# K2 OWNER'S MANUAL ERRATA

Rev. G-8, April 29, 2009

**Figure 5-9**

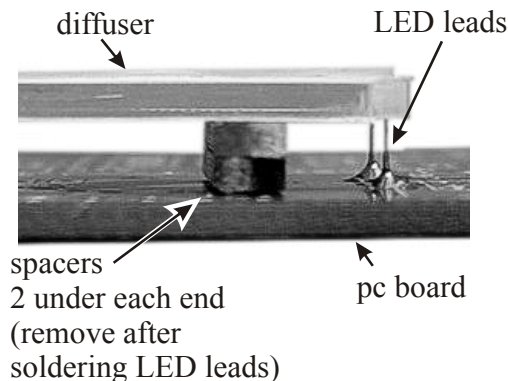
2. **Page 27, right column:** Delete the two existing steps and figures and replace them with the following:

Position the backlight assembly between the mounting holes labeled D2 and D3 as shown in Figures 5-9 and 5-10 with two 3/4" (19 mm) long spacers under each end. *The diffuser must be parallel to and 1/8" (3 mm) above the PC board.* Use a rubber band to hold the backlight assembly and spacers in place
